Proposal for a Corrigendum to ECE/TRANS/WP.29/GRE/2014/15

I. Proposal

Front position lamps (for a pair of lamps)

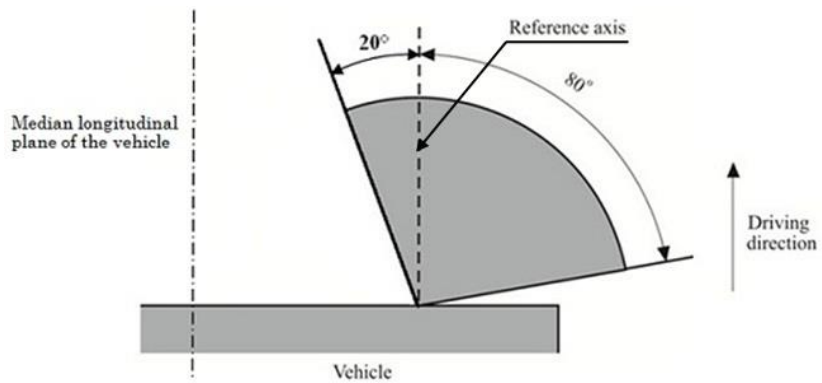
Annex 1,
Paragraph 1., correct the diagrams:

Configuration of the arrow pointing to the reference axes in each diagram is changed to evade misleading indication. No change to the requirement.

"2. Rear position lamps

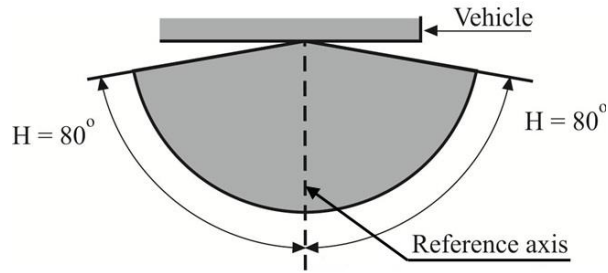
Paragraph 2., correct the diagrams:

"3. Direction indicators of categories 11, 11a, 11b, 11c and 12

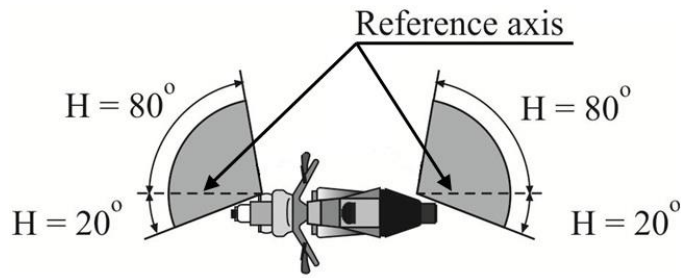
Paragraph 3., correct the diagram:

"4. Stop lamps
 $V = + 15^\circ/-10^\circ$

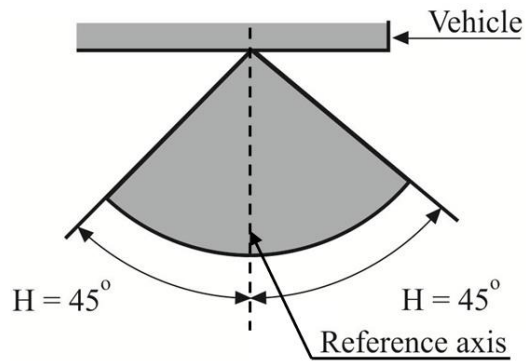
Paragraph 4., correct the diagram:
